Comments on document ECE/TRANS/WP.29/GRSG/2017/10

The text reproduced below was prepared by the European Association AEGPL to comment on document ECE/TRANS/WP.29/GRSG/2017/10 submitted by the expert from Poland.

Arrangement of the LPG equipment type approval mark

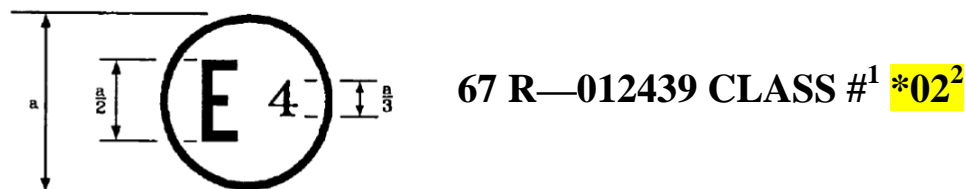
Annex 2A, amend to read:

$a \geq 5 \text{ mm}$

¹ Class 0, 1, 2, 2A or 3

² Number of extension, to be marked only on multivalve, pressure relief valve (discharge valve) and pressure relief device.

The above approval mark affixed to the LPG equipment shows that this equipment has been approved in the Netherlands (E 4), pursuant to Regulation No. 67 under approval number 012439. The first two digits of the approval number indicate that the approval was granted in accordance with the requirements of Regulation No. 67 as amended by the 01 series of amendments. The number of extension (02 in the example), preceded by the star symbol, is required only for the approval mark of the accessories of the container (multivalve, pressure relief valve (discharge valve) and pressure relief device).”

In order to solve this issue, as correctly raised by the Polish experts, AEGPL proposes to mark the extension number on the accessories relevant to the bonfire test (multivalve, pressure relief valve and pressure relief device) so that the fitting of any accessory not listed in the aforesaid list of approved configurations will be prevented/forbidden.
